Application No.	Applicant(s)					
		10/631,272	PAYNE ET AL.					
	Office Action Summary	Examin r	Art Unit					
		Jon A Szumny	3632					
	The MAILING DATE of this communication appears on the cover shelf to with the correspondence address Period for Reply							
A SHORTENED STATUTORY PERIOD FOR REPLY IS SET TO EXPIRE 3 MONTH(S) FROM THE MAILING DATE OF THIS COMMUNICATION. - Extensions of time may be available under the provisions of 37 CFR 1.136(a). In no event, however, may a reply be timely filed after SIX (6) MONTHS from the mailing date of this communication. - If the period for reply specified above is less than thirty (30) days, a reply within the statutory minimum of thirty (30) days will be considered timely. - If NO period for reply is specified above, the maximum statutory period will apply and will expire SIX (6) MONTHS from the mailing date of this communication. - Failure to reply within the set or extended period for reply will, by statute, cause the application to become ABANDONED (35 U.S.C. § 133). Any reply received by the Office later than three months after the mailing date of this communication, even if timely filed, may reduce any earned patent term adjustment.

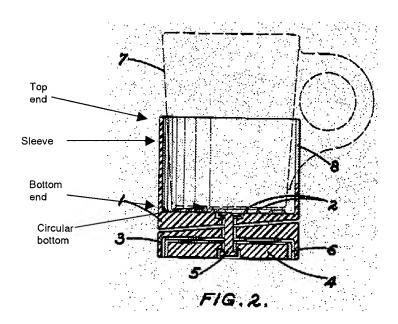
Sorth '614 discloses an attachment device (above) comprising a holder (1), a magnet (4) that is connected to the holder (via 5) wherein the magnet is of sufficient strength. However, Sorth '614 fails to specifically teach a cushion to be connected to the magnet wherein at least a portion of the cushion is inherently adapted to be

positioned between the magnet and an exterior surface. Nevertheless, Wemyss '656 divulges an attachment device (figure 2) including a magnet with a rubber cushion/boot (22 and 24, column 6, lines 3-14). It would have been obvious to one of ordinary skill in the art at the time the invention was made to have modified the magnet of Sorth '614 so as to have a rubber cushion/boot that could inherently be positioned between the magnet and an exterior surface so as to prevent a object being coupled with the magnet from being marred, in addition to providing for increased friction which would inherently provide for a superior coupling of the magnet and an exterior surface.

Sorth '614 in view of Wemyss '656 disclose the previously described invention wherein the holder is a cup with a sleeve connected to a circular bottom (above), wherein the sleeve has top and bottom ends, but fail to specifically teach the sleeve to be a conical sleeve with a top end having a greater diameter than a bottom end.
